Project 86-060-24  
December 1990

# Response to Comments and Proposed Reclamation Plan Modifications

Church Rock Site  
Gallup, New Mexico

United Nuclear Corporation  
Gallup, New Mexico

DATE	11-12-90	FIGURE	2-2	DRAWING NUMBER	86-060-E425
SCALE	AS SHOWN

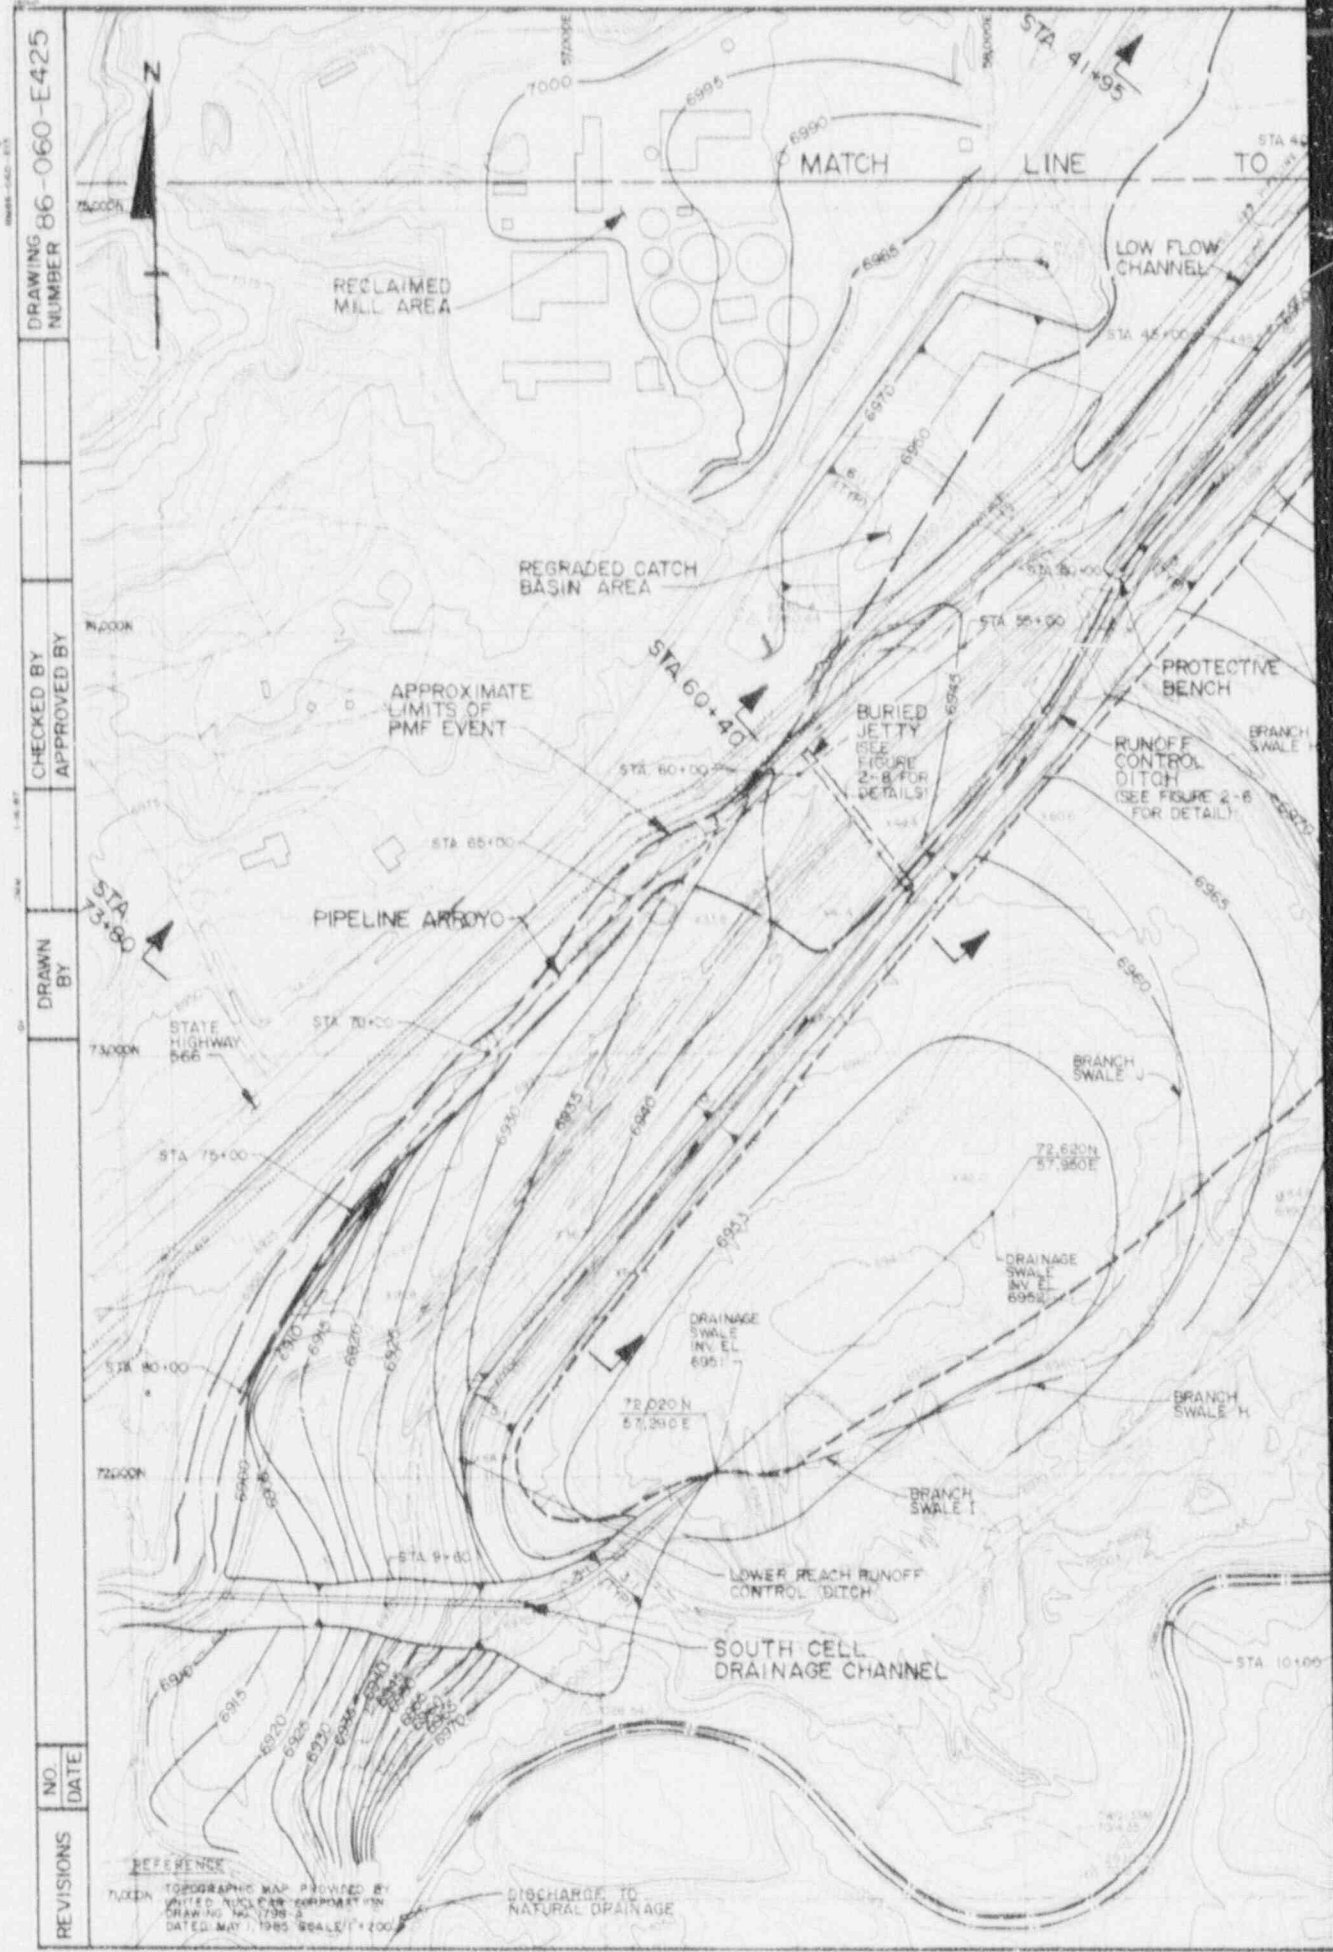
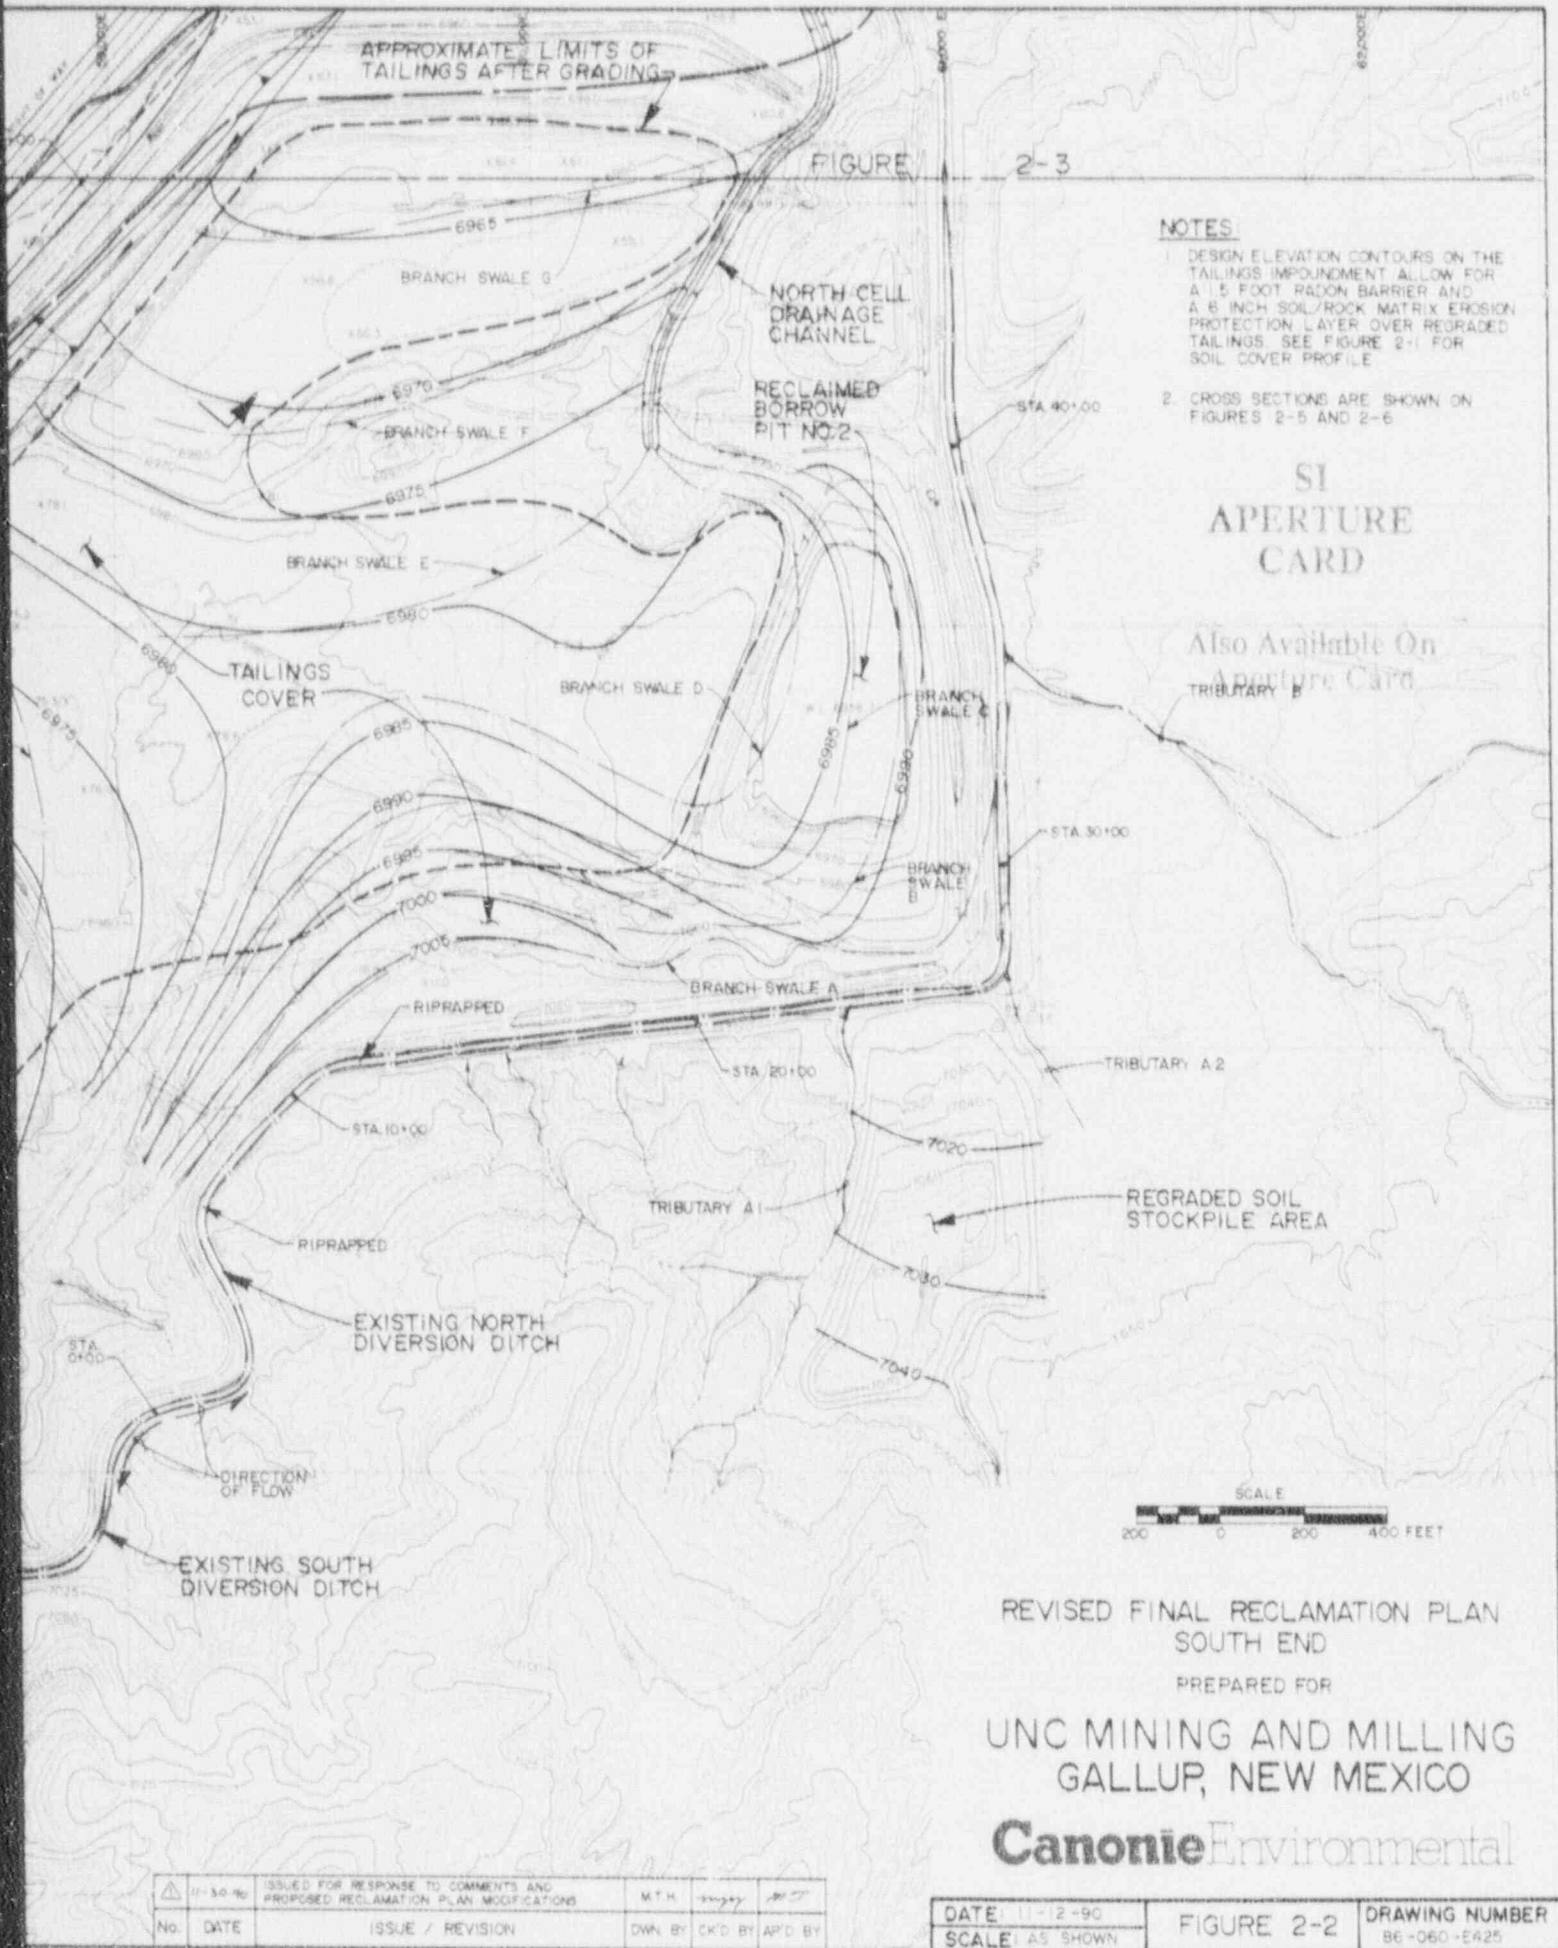
Figures 2-2 and 2-3 depict the proposed modified tailings impoundment configuration and grades at final reclamation. This configuration has been changed from that of the original reclamation plan (see Figure 1 of the August 31, 1988 responses to comments and Figure 3 of the September 12, 1990 response to comments) in three aspects. First, the surface contour elevations have been reduced 2 feet to reflect the resulting reduced tailings cover thickness. Second, additional swales have been added to the South Cell to collect surface water runoff. Third, the tailing's 2-foot soil cover will incorporate a 6-inch-thick soil/rock matrix to protect the cover from erosion. These proposed design modifications promote surface water drainage while maintaining the erosional stability of the tailings soil cover.

Figure 2-2 shows the location of the proposed jetty, while Figure 2-8 provides the jetty details. The jetty would be keyed into the nickpoint at its furthest extent to maximize the flow capacity within the nickpoint. The exact configuration of the eastern edge of the nickpoint will be determined in the field at the time of construction. For the present design, the low-flow channel was considered to be 30 feet wide and located at the west terminus of the jetty. The low-flow channel may be wider, depending on the nickpoint configuration.

Three critical locations are shown on Figure 2-2. These three confluences (A1, A2, and B) involve tributaries to the North Diversion Ditch that provide a large proportion of the total flow of the diversion ditches at discrete locations. None of the tributaries to the South Diversion Ditch provide a large proportion of flow to the ditch.

The geometry of the three confluences was evaluated to identify the confluence angle and the amount of material existing in the far ditch bank. Figure 2-2 shows that Tributaries A2 and B enter the North Diversion Ditch at shallow confluence angles of approximately 45 degrees. Thus, their flows will not impinge directly on the far ditch bank. Tributary A1 enters the North Diversion Ditch at about a 90-degree angle. This angle indicates that tributary flows would cause more turbulence at the confluence than would be caused by a shallower angle.
